Subject: RE: [EXTERNAL] NAB1506157520 LAGUNA SALADO SOUTH #001

I have recently reviewed the remediation closure report for NAB1506157520 LAGUNA SALADO SOUTH #001 and have a question for you regarding this. Referring to the attached Tables which

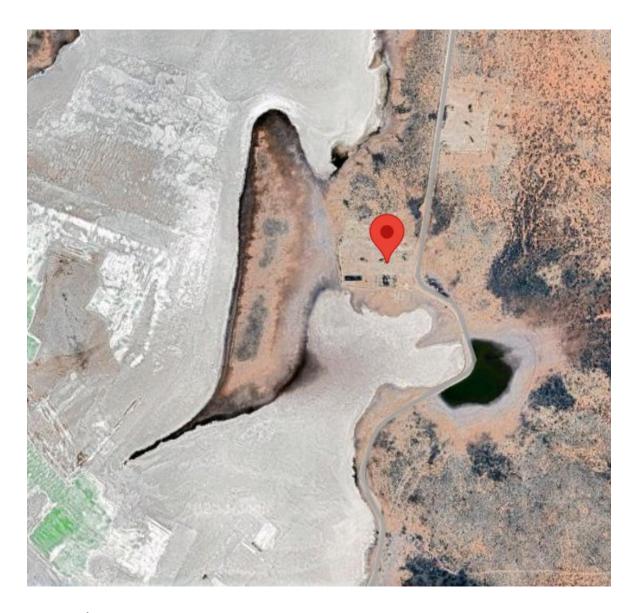
were extracted from the report, explain why the samples collected at surface on 3/10/25 within 10 feet of the original BG North sample point (as shown on the Investigation Sample Map) differ so greatly in their chloride concentrations from the previous samples collected on 9/13/24? I look forward to hearing what you have to say regarding this.

The follow-up samples collected on 3/10/2025 near BG North show much lower chlorides and Non-Detect on TPH.

One possibility for the differences we are noticing in the soil samples could be attributed to dust blowing in and settling on the surface. The source of this dust would be the nearby salt evaporation pond utilized in potash production. Given that our site is located at the edge of this large, several hundred-acre salt evaporation pond that does not have a liner to prevent salts from mixing with soils, we might see fluctuations in soil composition. Salt impacted soils could be deposited during one season and vary significantly in the next season, impacting surface samples.

This evaporation pond often remains dry, which can lead to the generation of dust laden with high chloride values. Seasonal dust storms are common in Southeast New Mexico, and these storms could potentially affect nearby soil conditions, depending on the prevailing wind direction. Understanding these factors will be crucial for our determining a suitable background value for chlorides, and I appreciate any further insights or recommendations you might have as we move forward on this unique site.

I do not think this is the only possibility, but I am inclined to think that this particular pad has a high likelihood of having direct influence from the adjacent evaporation ponds, simply due to proximity. Does NMOCD has any specific requests for the establishment of acceptable background chloride values, given this well pad is situated on the edge of a basin filled with soil that has exceeding high chlorides?
